Subject: **Comments: Draft Permit MN0021440 for Spring Grove Wastewater Treatment Plant**
Public Comment Period: March 25, 2024 through May 24, 2024
NEC/Dayforce Remediation of TCE contamination, MPCA ID SA0000168

NEC/Dayforce TCE Remediation Project
Spring Grove, MN 55974

PHOTOGRAPHS:
Comments on Draft NPDES Permit,
Spring Grove Wastewater Treatment Facility
MN0021440: Spring Grove, Minnesota

FIGURE 1

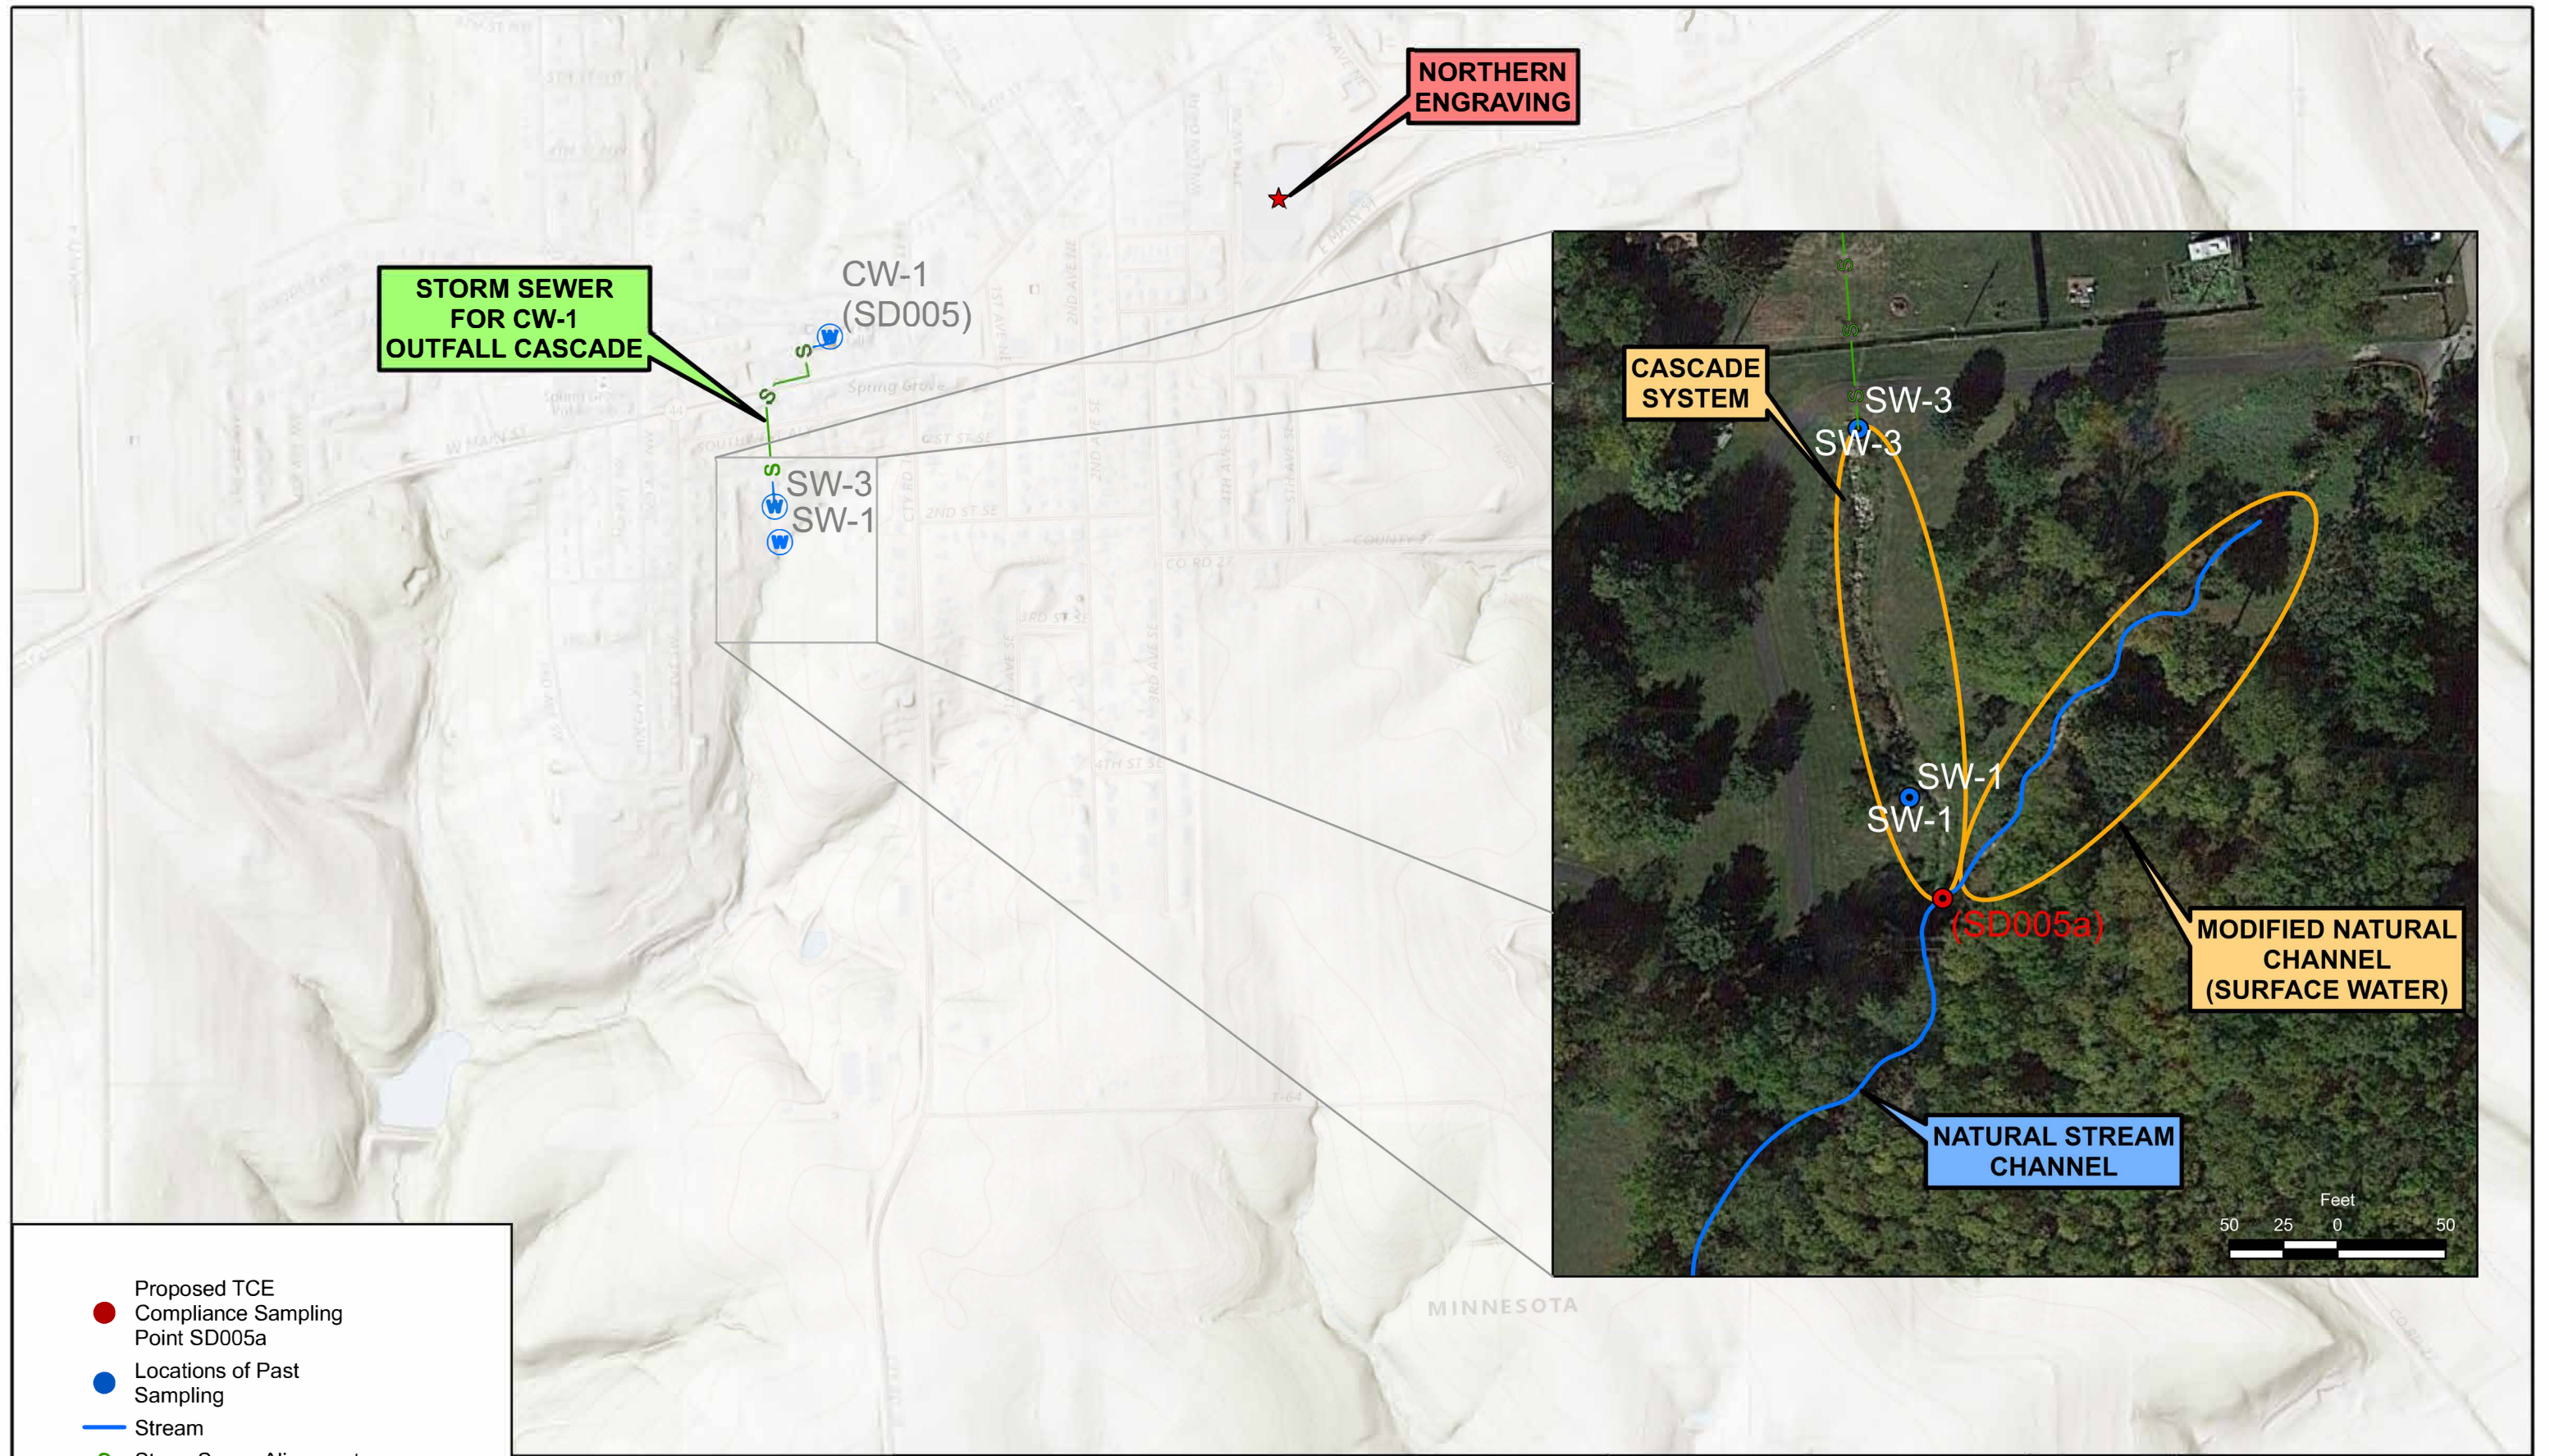
Attached Figure 1 illustrates key features of the NEC/Dayforce-designed remedial pumping of CW-1, from supply well through the storm sewer components mentioned, and discharge via pipe to the treatment works (cascade system) prior to its discharge into surface water.

The location of this additional sampling station is at the end of the treatment cascade system channel, just upstream of the point where it discharges into the natural, intermittent stream channel. The coordinates of this station would be (UTM NAD83) as follows: X: 609965.470386 Y: 4823767.759141

NEC/Dayforce submits that this sampling location is the appropriate location for the TCE compliance monitoring point and that the permit be revised accordingly. Proposed sampling location SD005a is at the downgradient end of the engineered system constructed and approved by the MPCA for treating the TCE-containing water from CW-1; this station would be prior to its entry into the surface water feature, Unnamed Creek tributary to North Bear Creek. NEC/Dayforce has invested in the construction and upgrade of the cascade because it provides treatment of the groundwater discharged from CW-1. Using this point for TCE compliance monitoring is consistent with the original purpose and intent of this constructed channel.

Therefore, NEC/Dayforce requests the permit be revised to identify SD005a as the TCE compliance monitoring location for meeting the TCE concentration limit for remediation activities undertaken by NEC/Dayforce. Monitoring the discharge of water treated via cascade aeration generated by the pumping of CW-1 as part of the MPCA-approved Response Action is the appropriate point of compliance for the TCE limit.

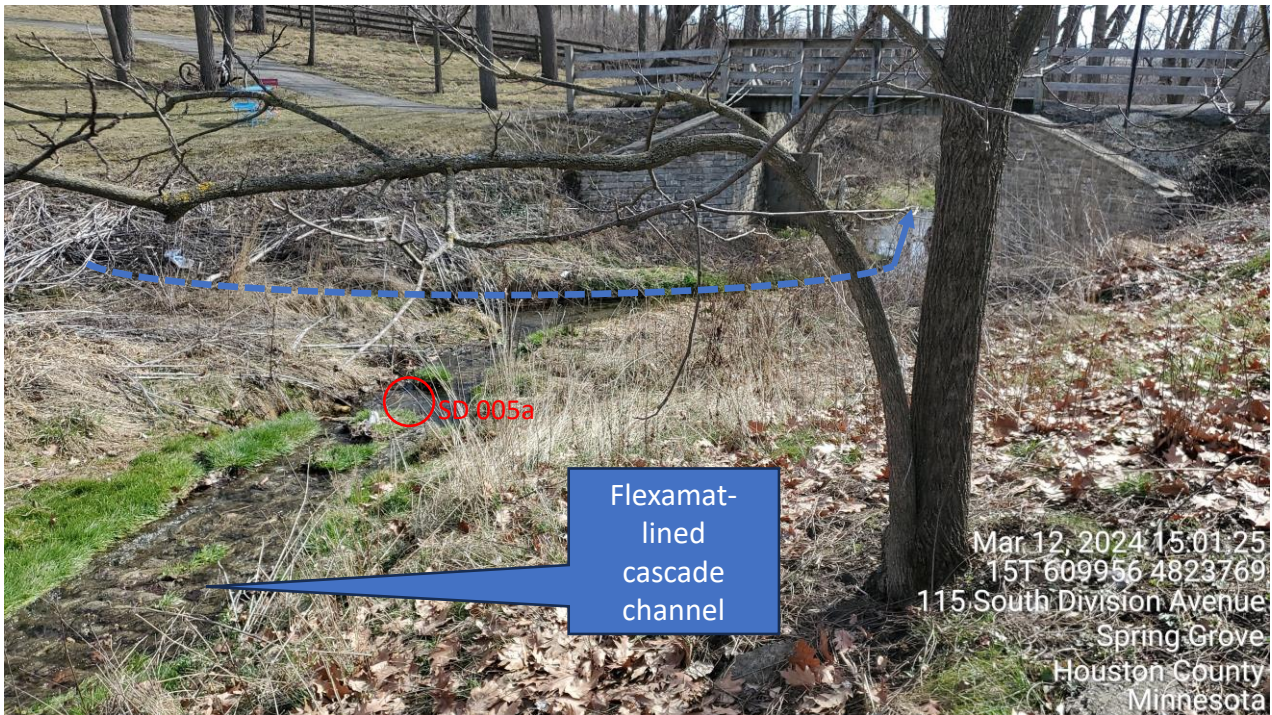
PHOTO NO. 4: Photo facing south, taken at base of cascade aeration channel just before it discharges to the natural stream channel (dashed line) which would flow from left to right in this picture. The proposed sampling station SD 005a is depicted. This photo was taken just upstream of a recreational trail bridge crossing the channel.
